**The Peelle Company**

## TECHNICAL BULLETIN

Moisture Resistant Interlocks and Gate Contacts  
Explosion Resistant Interlocks and Gate Contacts

**CAST BOX**

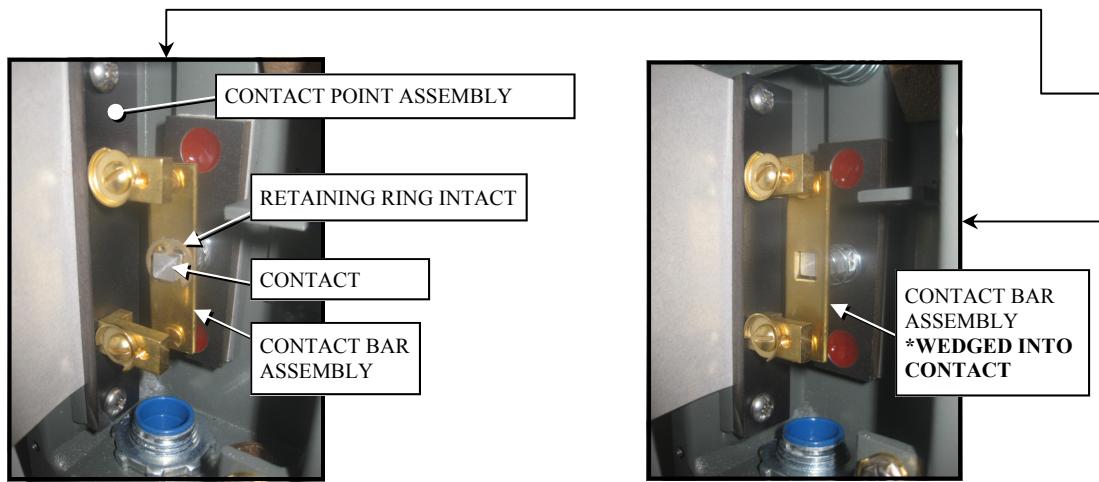
Peelle has discovered a potential problem with the DC (door closed) contact in the lower box of the Nema 4/4X/7 interlock. If the retaining ring that secures the contact bar assembly to the contact stud is removed or fails, the contact bar assembly could wedge against the contact point assembly and provide a false DC (door closed) signal. The issue is similar in the gate contacts listed above except that the signal would be GC (gate closed).

**RETAINING RING INTACT  
(NORMAL CONDITION)**

**RETAINING RING DISLODGED  
(PROBLEM CONDITION)**

Peelle has designed replacement parts. The new replacements allows the contact bar to fall off the contact stud should the retaining ring be removed or fail.

**Replacement Kit Number - 030015**

**Replacement Part Number - 035510**
